STRYKER LOCAL SCHOOLS
1957 Building Renovation
Stryker, Ohio

B6-4512

ADDENDUM NO. 4

CHORD REINFORCEMENT (2 L'S) FOR GIRDER: BOTTOM CHORD

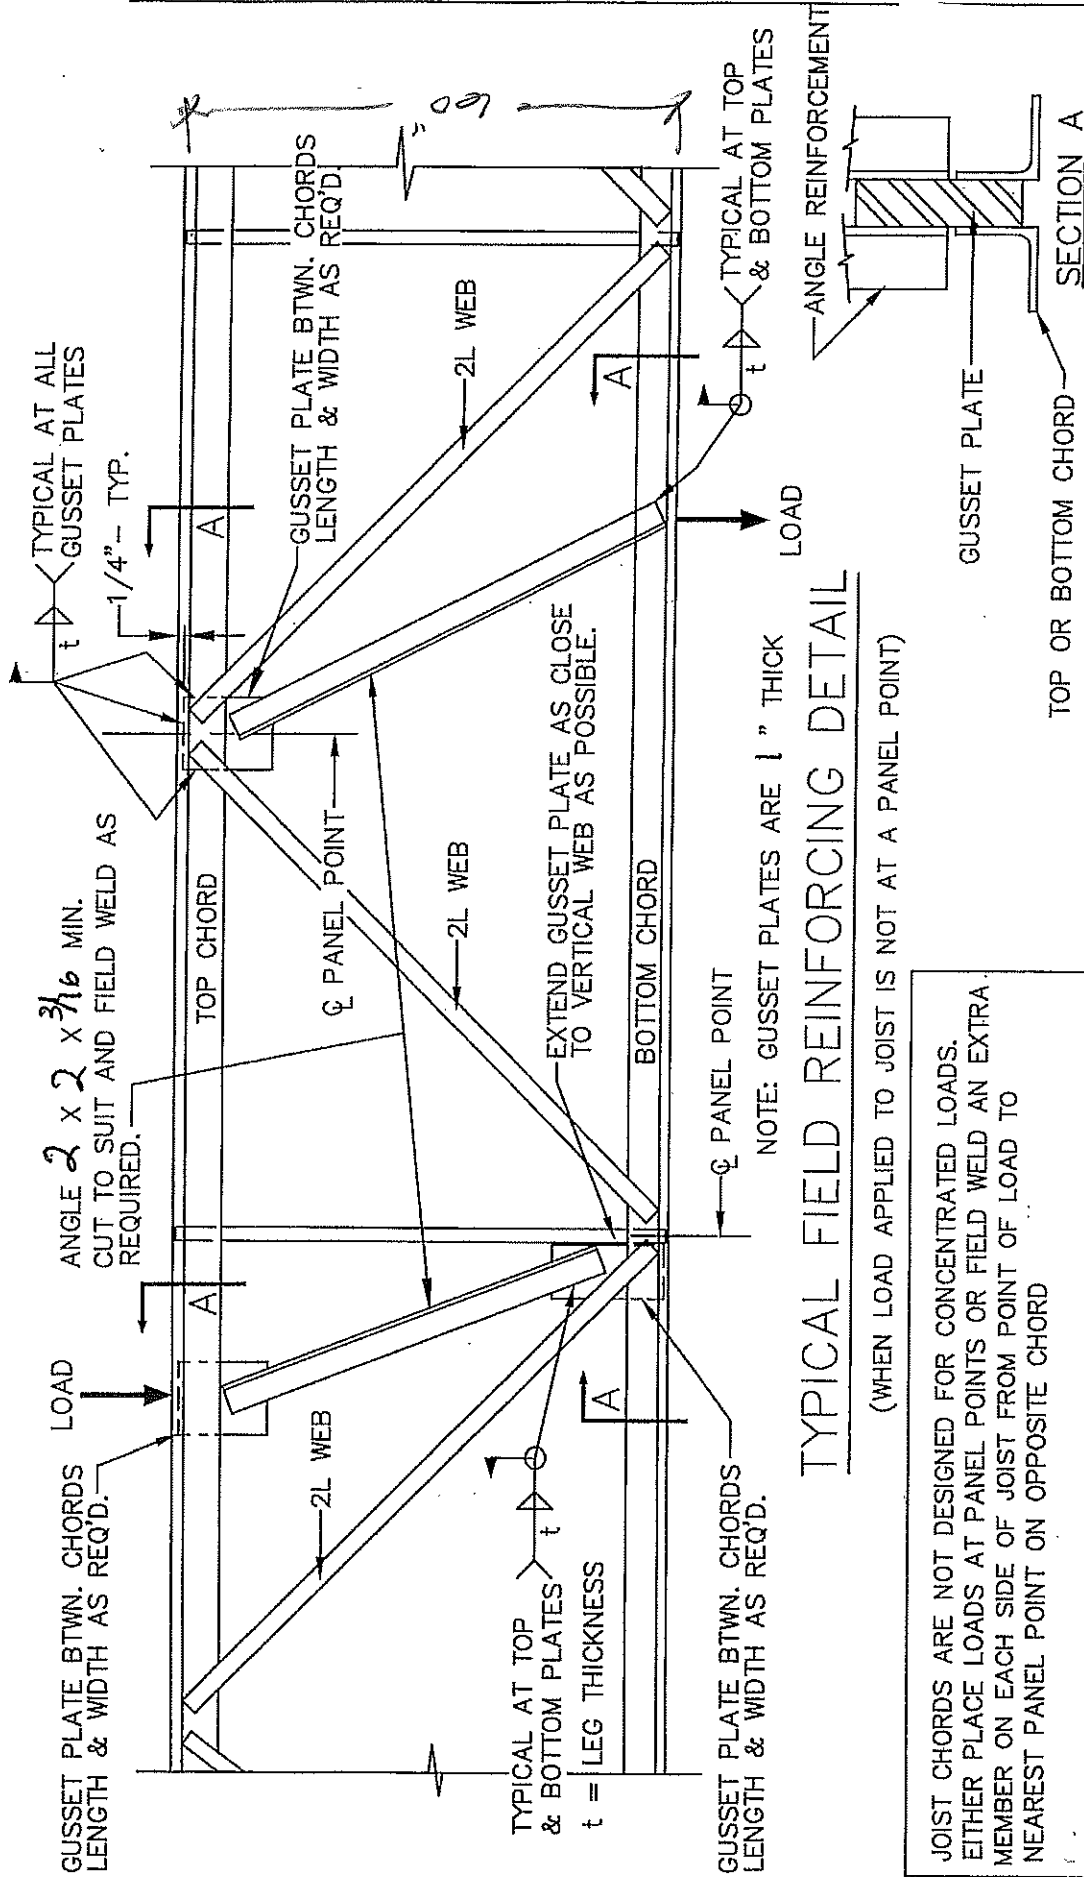
- STEP 1: INSTALL ANGLE REINFORCEMENT TO EACH SIDE OF BOTTOM CHORD ANGLES AS SHOWN.
 STEP 2: WELD NEW TWO ANGLES TO BOTTOM CHORDS AS SHOWN.

ALL WELDING TO BE DONE WITH E70XX ELECTRODES BY A.W.S. CERTIFIED WELDER IN ACCORDANCE WITH A.W.S. STANDARDS.
 FIELD MODIFICATION FOR:

2. For each unit, include reinforcement in accordance with attached Chord Reinforcement details.
 - a. Include bottom chord reinforcement at 4 truss panels for each unit.
 - b. Include interior web reinforcement with gusset plates at 2 truss panels for each unit.

CHORD REINFORCEMENT (2 L'S) ON GUSSET PLATES FOR DOUBLE ANGLE INTERIOR WEBS

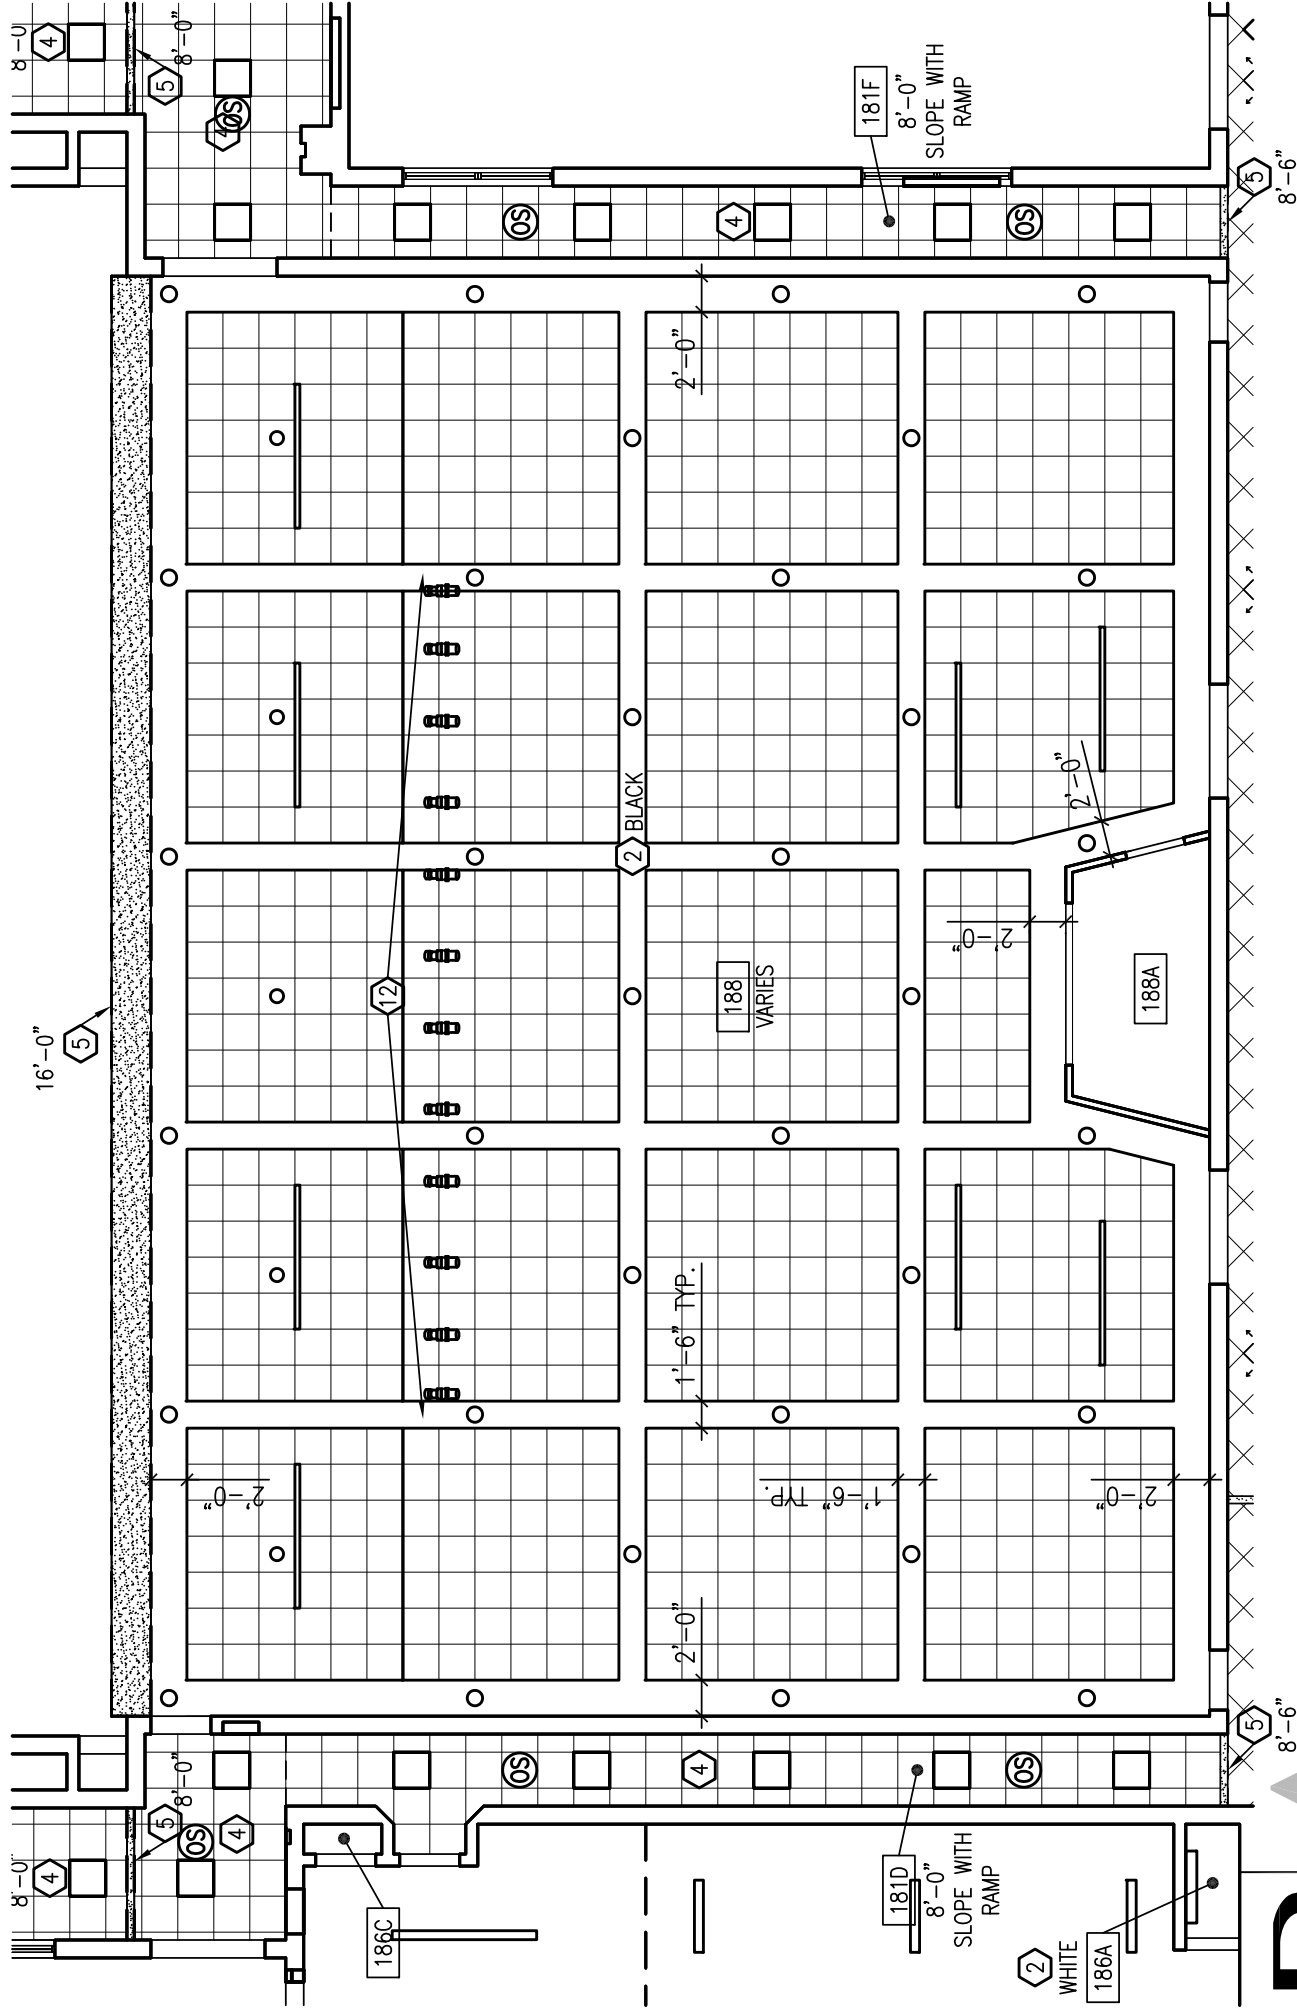
TYPICAL FIELD FIELD REINFORCING DETAIL

(WHEN LOAD APPLIED TO JOIST IS NOT AT A PANEL POINT)

JOIST CHORDS ARE NOT DESIGNED FOR CONCENTRATED LOADS.

MEMBER ON EACH SIDE OF JOIST FROM POINT OF LOAD TO NEAREST PANEL POINT ON OPPOSITE CHORD

ALL WELDING TO BE DONE WITH E/OXX ELECTRODES BY A.W.S. CERTIFIED WELDER IN ACCORDANCE WITH A.W.S. STANDARDS.
FIELD MODIFICATION FOR:
